Date: 10/07/16
To: Studio Trailer Owners
From: Multiquip Product Department
Subject: Studio Trailer A-Frame Hairline Cracks — **Immediate Action Required**

Service Bulletin

Studio Trailers TRLR1400AE/AH

Product Group: Studio Trailers	Date Issued: 10/07/16	Service Bulletin No. TL20160921
Bulletin Type <input checked="" type="checkbox"/> Immediate Action Required <input type="checkbox"/> Information Only <input type="checkbox"/> Recommended Change		Models/Series Affected: TRLR1400AE/TRLR1400AH SEE ATTACHED LIST FOR VIN/SERIAL NUMBER Bulletin Expiration Date: N/A

Figure 2. Inner Reinforcement Plate Installation

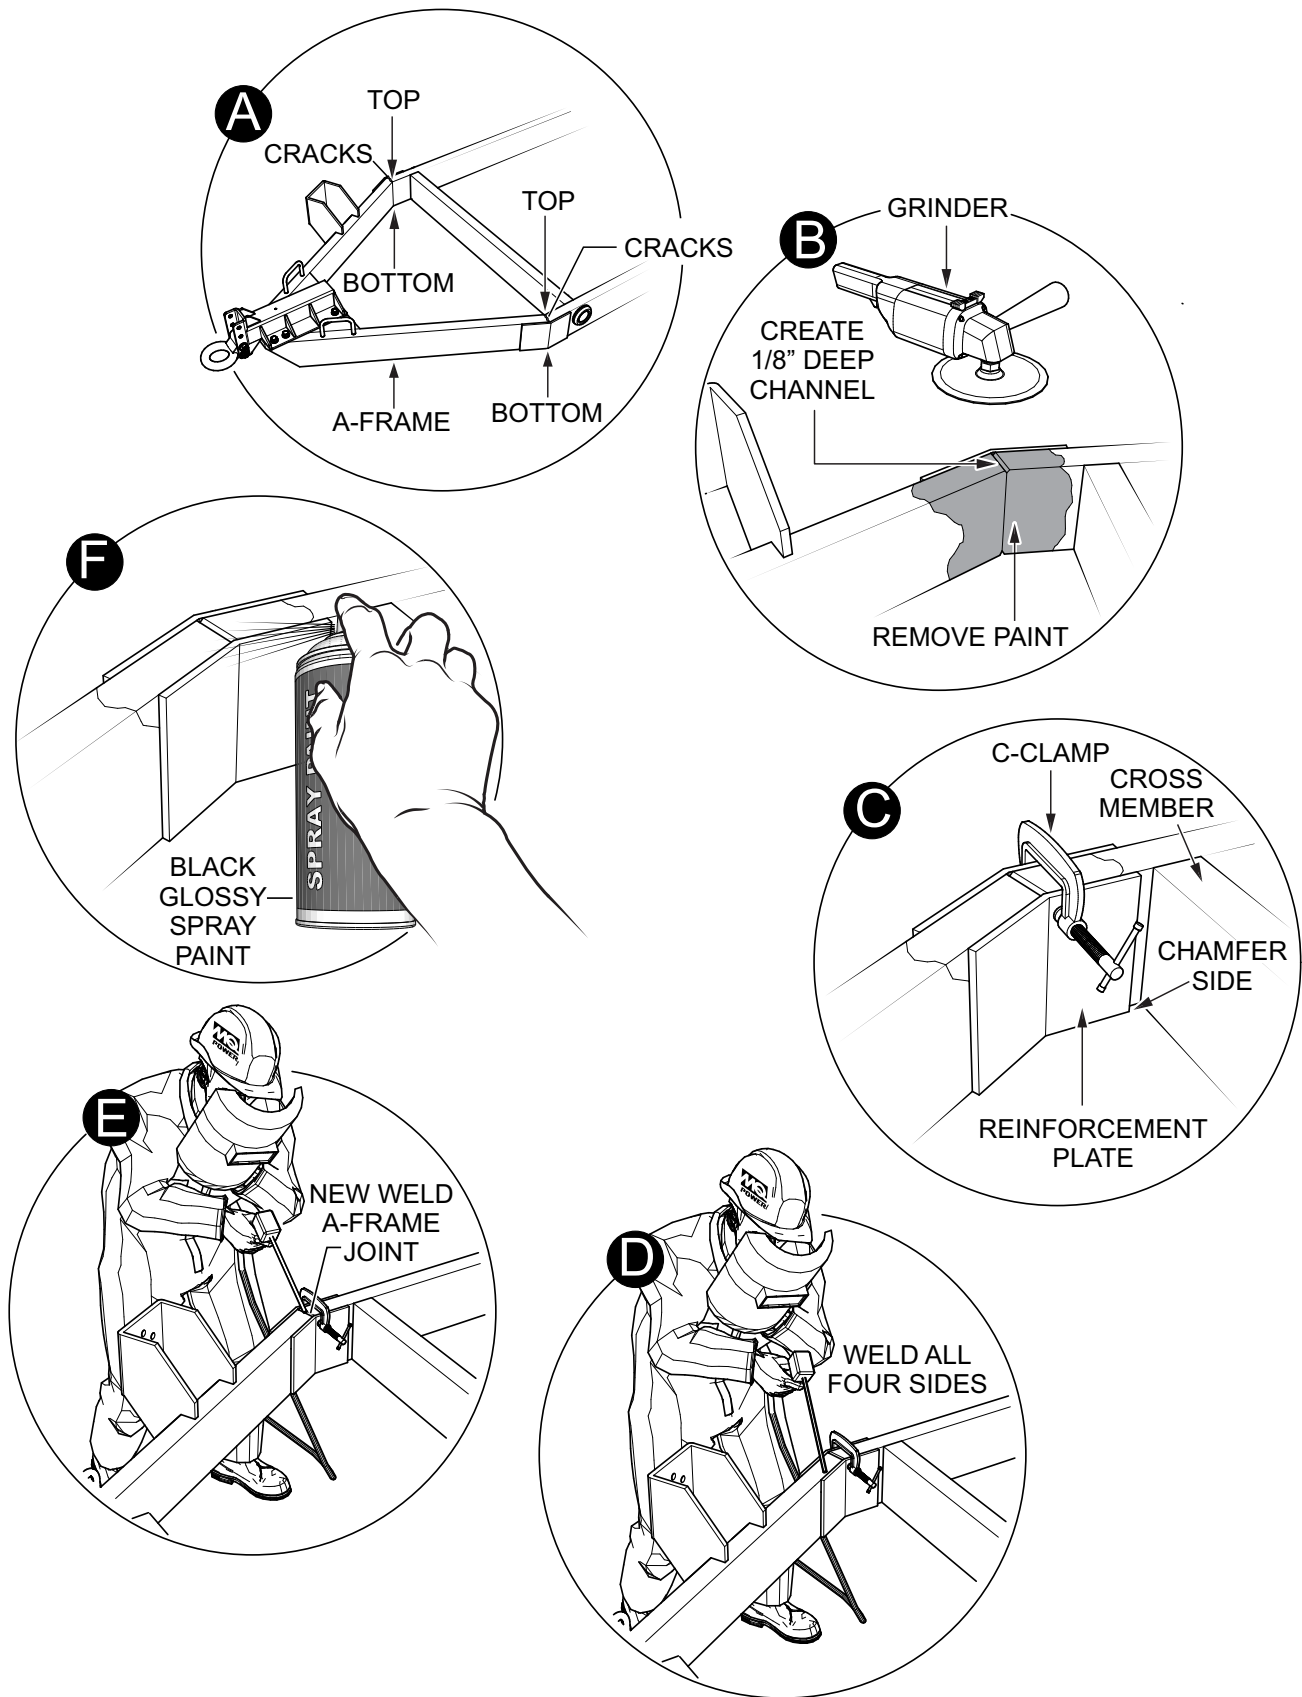
Details Problem: a. A production run of studio generator trailer frames may experience hairline cracks at the TOP and BOTTOM of the A-frame joint. Solution: a. Immediately inspect the trailer A-frame joint for hairline cracks as referenced in Figure 2A

2. Grind off existing welds 1/8" deep (Figure 2B) at the **TOP** and **BOTTOM** of the A-frame joint.
3. Place inner reinforcement plate (EE59670) onto trailer frame as shown in Figure 2C. Secure reinforcement plate with C-clamps.

Make sure the chamfer side of the inner reinforcement plate is placed adjacent to the trailer cross-member.

4. Weld inner reinforcement plate (Figure 2D) onto trailer A-frame. Weld ***all four sides*** of inner reinforcement plate.
5. Apply new welds (channel) to the **TOP** and **BOTTOM** of the A- frame joint(Figure 2E).
6. At the completion of the welding process, remove any flux, burrs or rough edges from the welding area.
7. Clean the top and bottom areas on the A-frame with a wire brush, then paint area with ***black glossy spray paint*** (Figure 2F). Let welded area cool before painting.

1. Using a grinder, ***remove paint*** from area to be heated during welding (Figure 2B).
